Service Information

Model NAKAMICHI 580, 581, 582
Serial No. from

Subject Countermeasure for Unexpected
Shut-off in Playing or Recording

No. NR-0037 (1/2)
Date 8/20/79

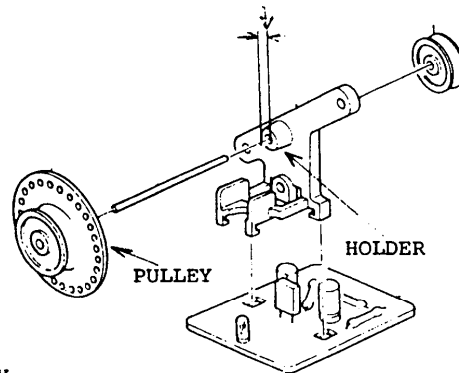
A certain number of the 580 series have the Auto Shut-off Ass'y in which the Shut-off pulleys have been assembled too tightly. These pulleys rotate hardly in playing or recording, and this causes the shut-off problem.

This service information will show how to readjust these pulleys' condition. There should be 0.3mm - 0.5mm gap between the pulley and the holder so that they can rotate smoothly.

There should be 0.3mm-0.5mm gap between PULLEY and HOLDER.

1. Disassembling

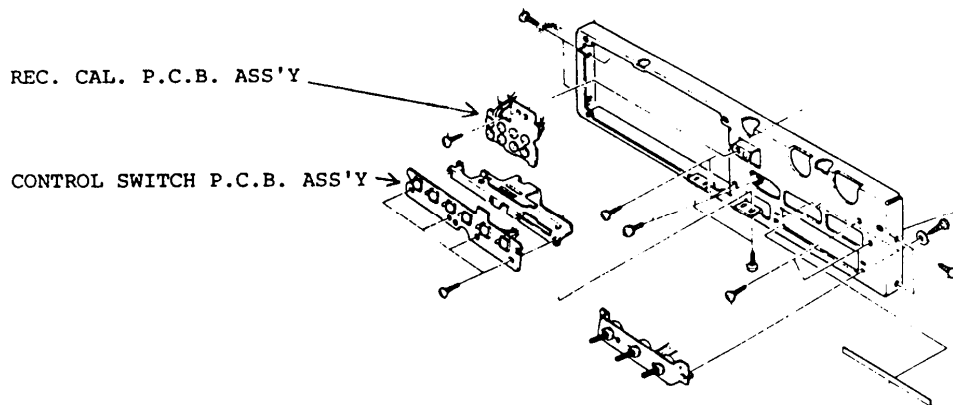
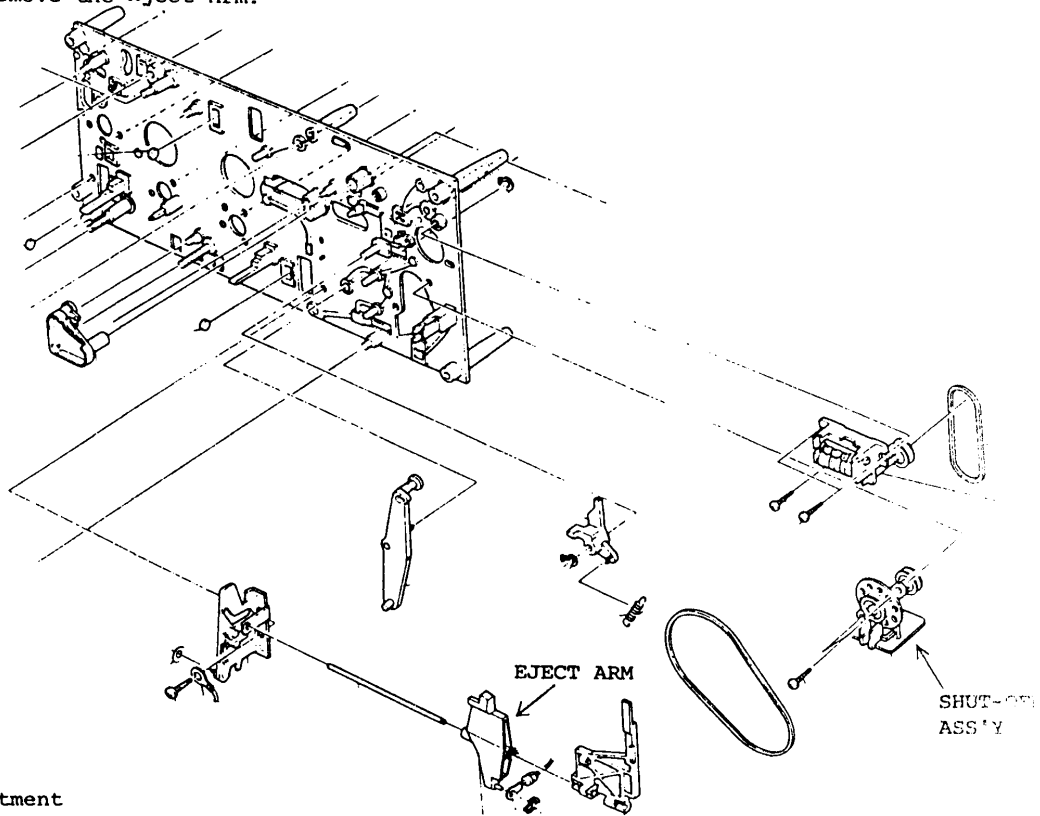
- 1-1). Remove the Top cover Ass'y.
- 1-2). Remove the Front Cabinet Ass'y.
- 1-3). Remove the Record Cal. P.C.B. Ass'y.
- 1-4). Remove the Control Switch P.C.B. Ass'y.

1-5). Remove the Eject Arm.

2. Adjustment

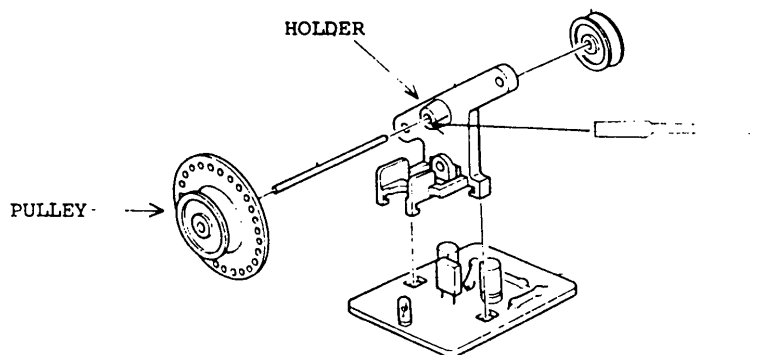
2-1). Insert screw driver to inside of the Shut-off Pulley.

2-2). Push the Pulley by screw driver so that you can make 0.3mm-0.5mm gap between the Pulley and the Holder.
(Do not push the Pulley too hard. The Pulley will be taken apart from the shaft easily.)
